Subject: **Sherman, Crystal
& Island Falls**

Federal Project No: IM-1681(920)E

State PIN: 016819.20

Amendment No. 1

STATE OF MAINE
 DEPARTMENT OF TRANSPORTATION
STANDARD DETAILS
 (80 114-77)
ALUMINUM BRIDGE RAILING
 2 - BAR (SEMI-ELLIPSE)
 TYPE "A"

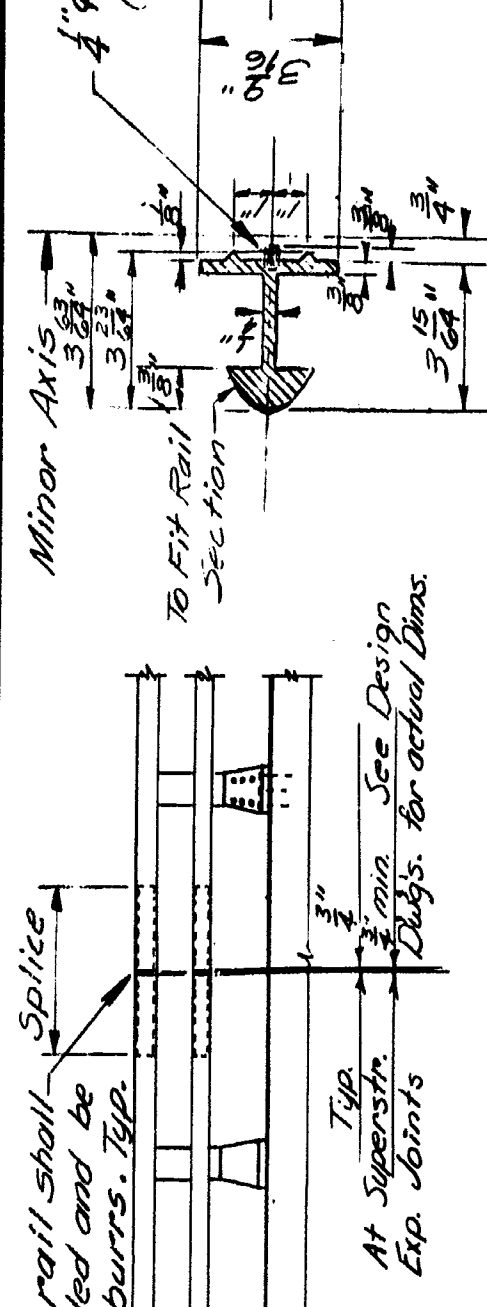
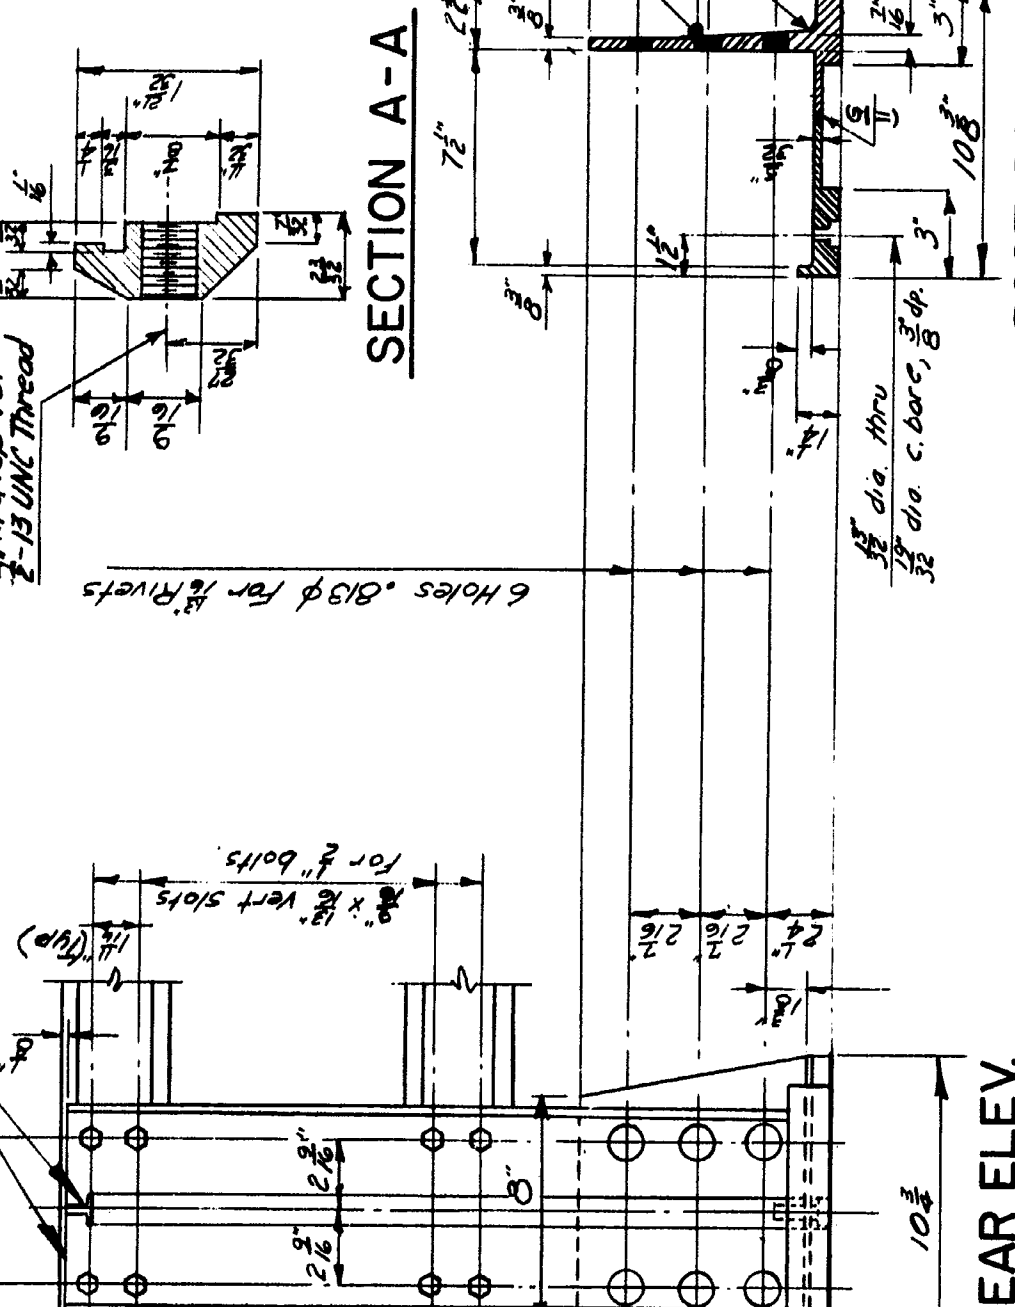
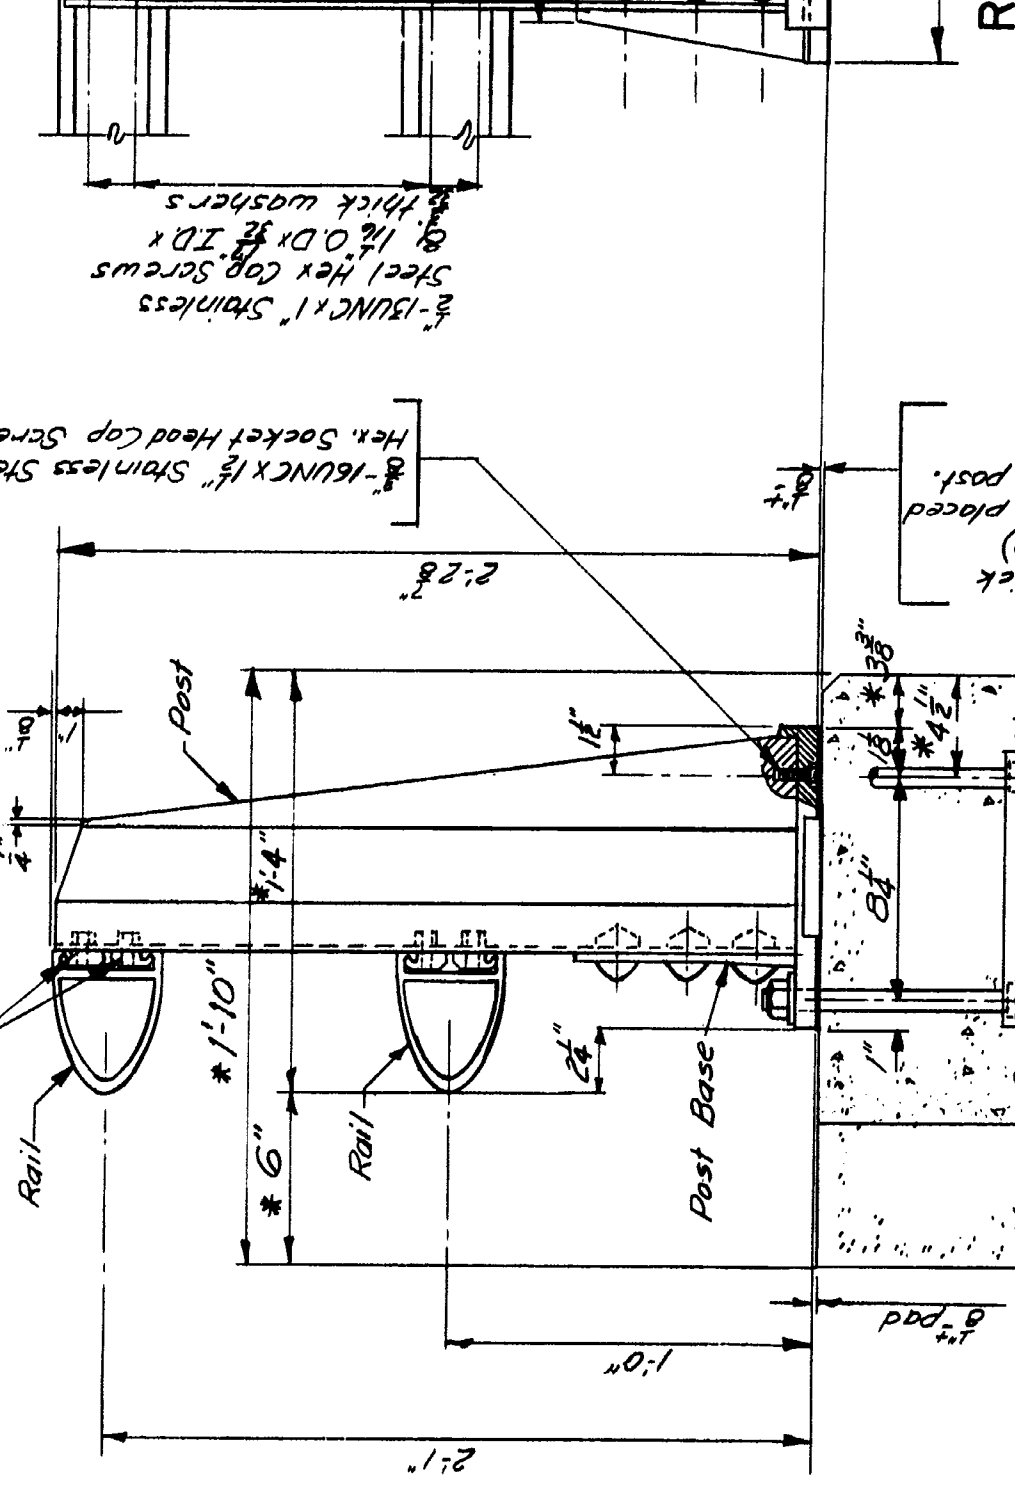
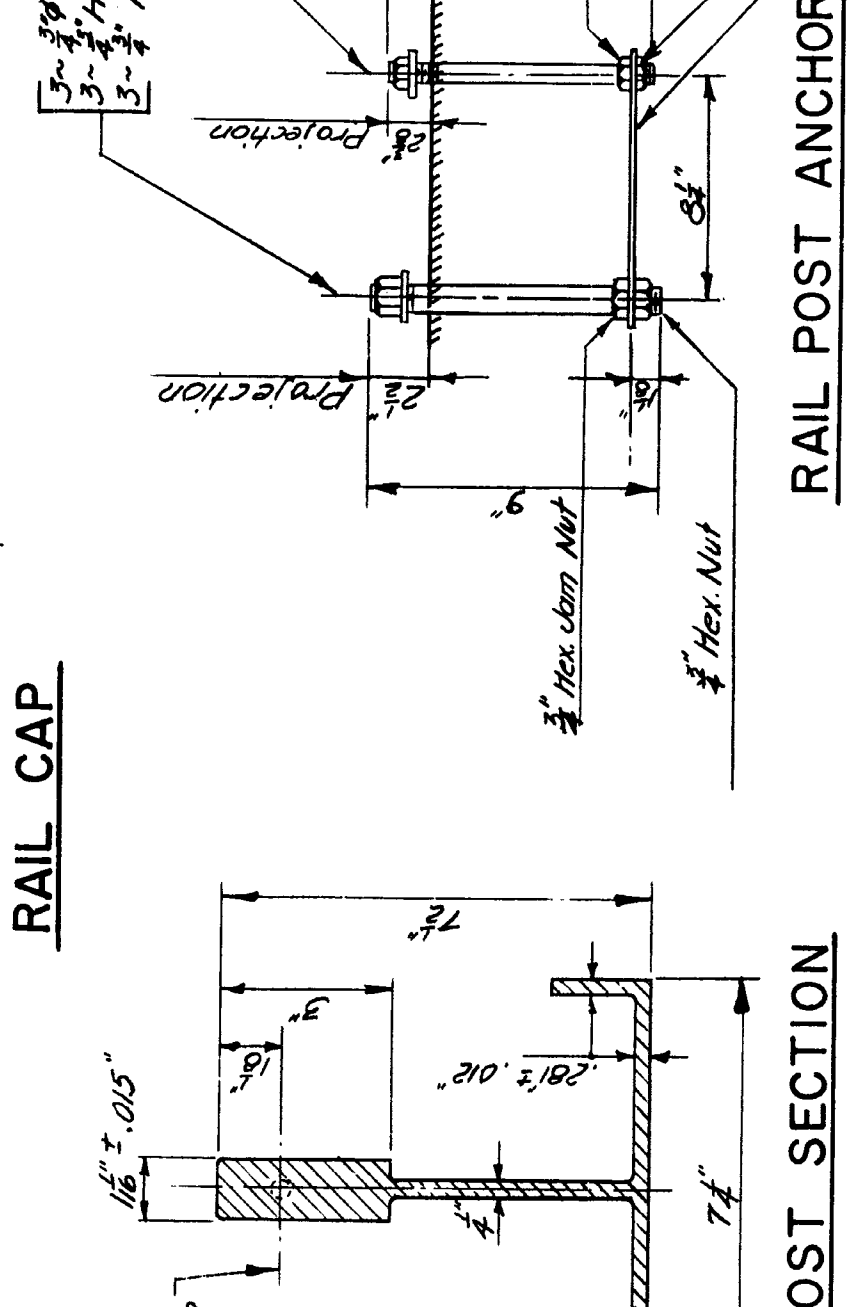
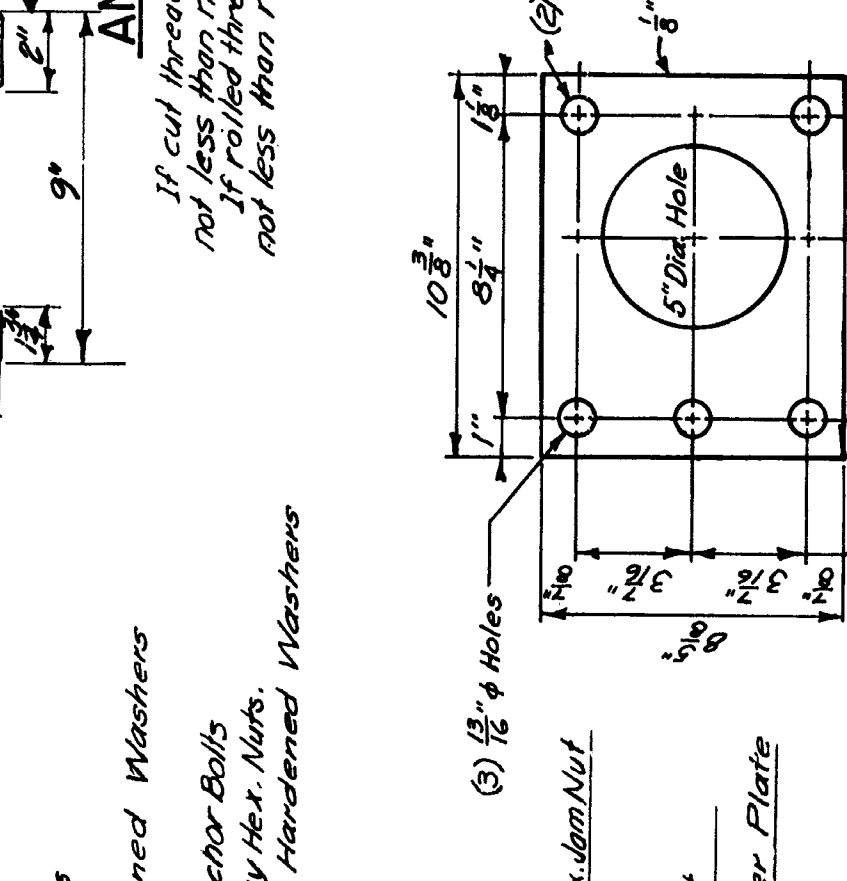
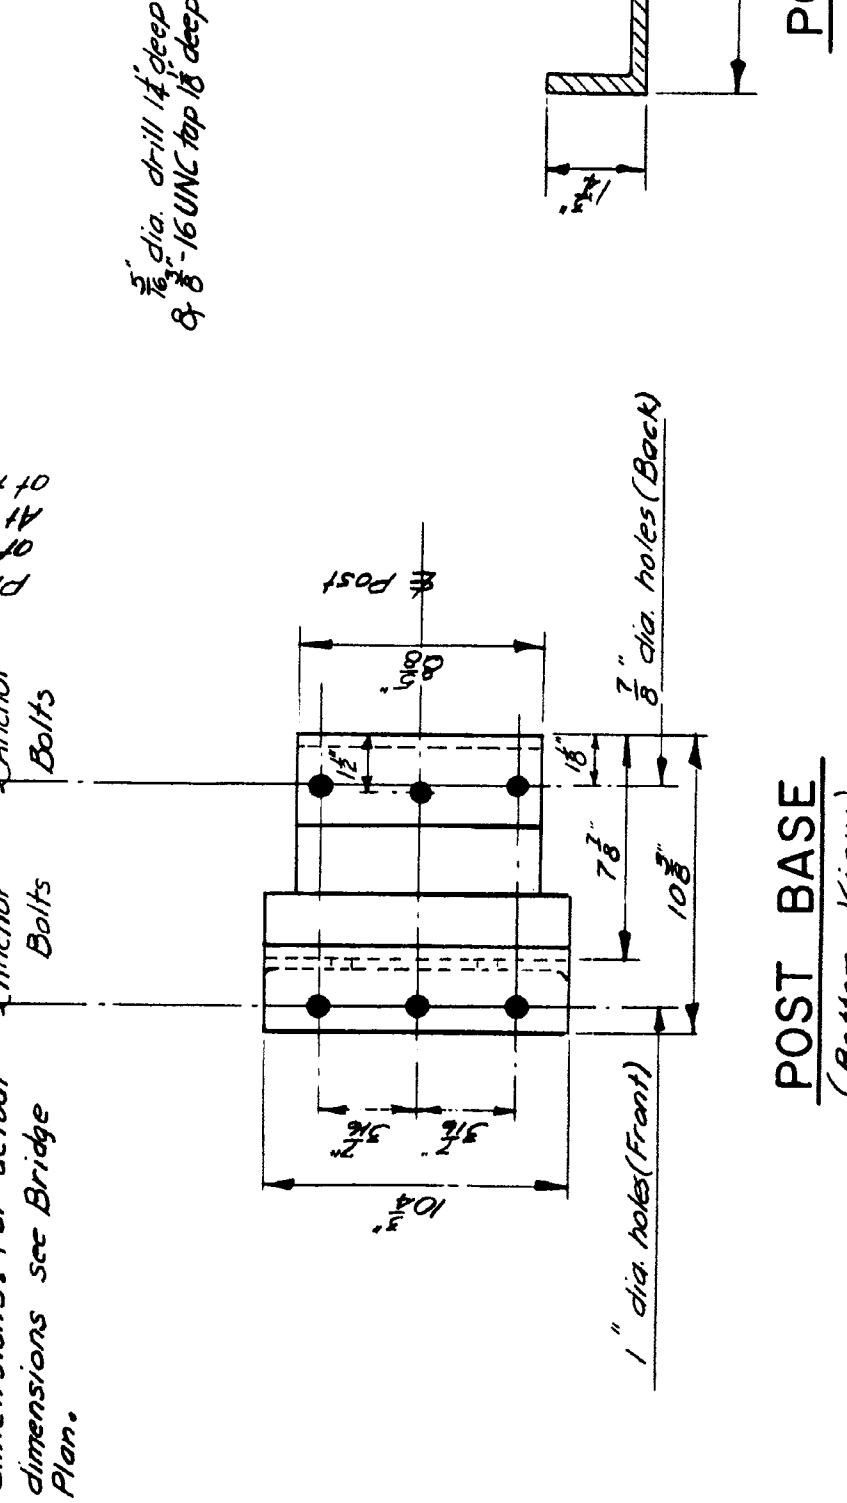
Question: Special Provision 507 (Furnish Aluminum Bridge Rail Components) states that all Type Z rail components shall be of the type and dimensions shown on MaineDOT Standard Details BD 114-77. Where can this standard detail be found?

Response: Please see attached plan sheet.
